TECHNICAL COMMITTEE RECOMMENDATION

TECHNICAL COMMITTEE: Bicycle Technical Committee

DATE OF ACTION: 13 June 2003 (*revised 08 January 2004*)

TOPIC: Revisions to Chapter 9B of the MUTCD regarding the M1-9 Sign

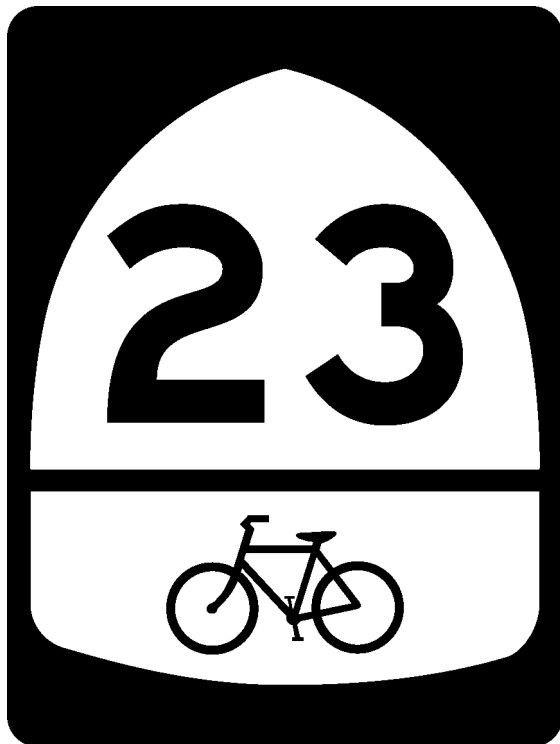
1. Revise the language in Chapter 9B to clarify that the M1-9 is intended for use with AASHTO's network of formally established US Numbered Bicycle Routes.
2. Revise the design of the M1-9 to emphasize its applicability to bicycle routes and to reduce the potential of confusion with other route marker signs.

The design of the M1-9 sign was originally established by FHWA in the 1978 MUTCD. In 1982, AASHTO recommended that the design of the M1-9 be changed to emphasize the bicycle symbol and reduce the size of the route number (see Appendix B). FHWA concurred and changed the design of the M1-9 as part of revisions to the 1978 MUTCD. However, the Standard Highway Signs (SHS) book detail for the M1-9 was not changed, and so nearly all agencies continued to use the original M1-9 design as defined by the SHS book, not the MUTCD.

During development of the 2000 MUTCD, the BTC noted this discrepancy between the SHS and MUTCD in the design of the M1-9, but was unaware of the correspondence in Appendix B. Based on the information then available, the BTC recommended that the design as shown in the SHS be used, and FHWA changed the M1-9 back to the original design in the Final Rule adopting the 2000 MUTCD. After the correspondence between AASHTO and FHWA in Appendix B was rediscovered earlier this year, the BTC reconsidered its earlier recommendation, and now recommends that the M1-9 be revised back to the large bike / small numeral configuration.

Existing M1-9 sign

Revised M1-9 sign

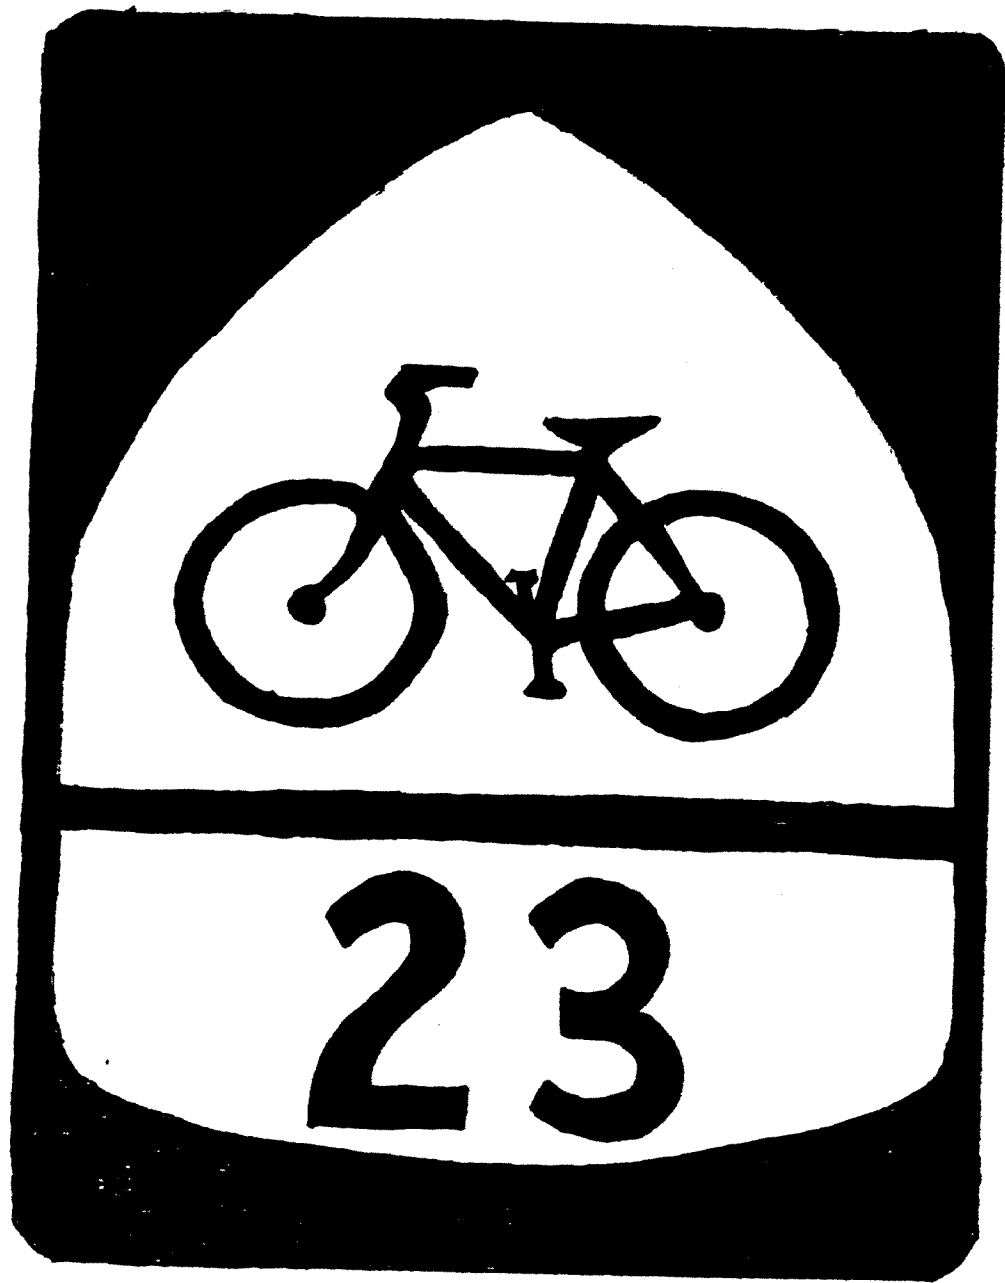
The AASHTO Special Committee on U.S. Route Numbering and the AASHTO Executive Committee recommend that the present U.S. Bicycle Route sign as shown in the Manual on Uniform Traffic Control Devices be modified as shown in the attached sketch. We believe this change can be considered an editorial modification which would not necessitate a formal rulemaking proceeding.

The reason for the change is to present an immediate impression of a "bicycle numbered route" rather than a "highway numbered route which can also be used by bicyclists."

We agree with you and will make an editorial change to the Manual on Uniform Traffic Control Devices (MUTCD). The editorial change will appear in MUTCD Revision No. 3 as the camera ready pages for printing of Revision No. 2 have already been prepared. We anticipate publication of Revision No. 3 early next year.
